November 20, 2009

Re: Recommended Changes to PMN (Maneely) Ordinance

200-194.2 Planned Mixed Use Neighborhood

**Figure 4**  
**Bicycle Ramp Access to Shared-use Path <sup>(1)</sup>**

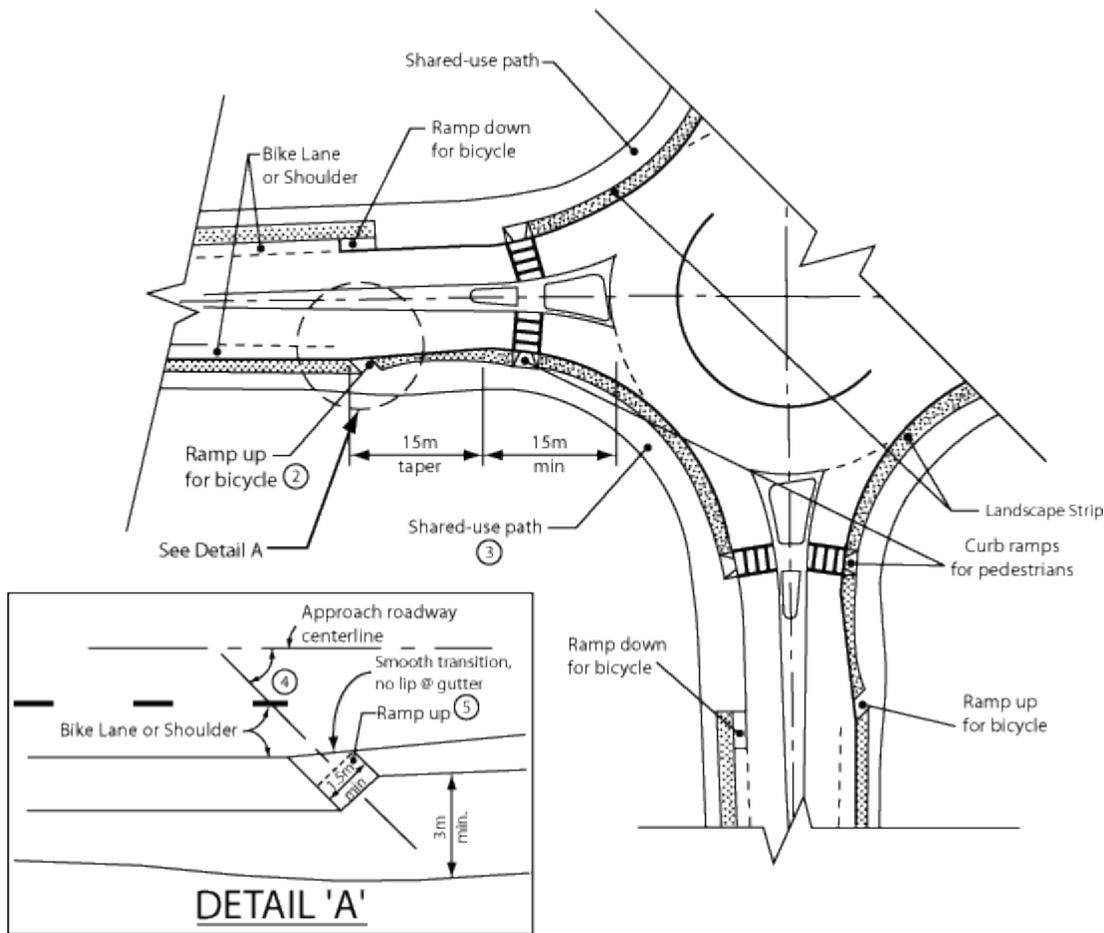
WWBPA: Add to the end of paragraph (3):

The roundabout shall include pedestrian and bicycle facilities, including marked crossings, sidewalks, a shared-use path, and designated bike lanes with ramps to and from the shared-use path, to accommodate bicyclists who prefer not to use the circulatory roadway, as shown in Figure 4 below.
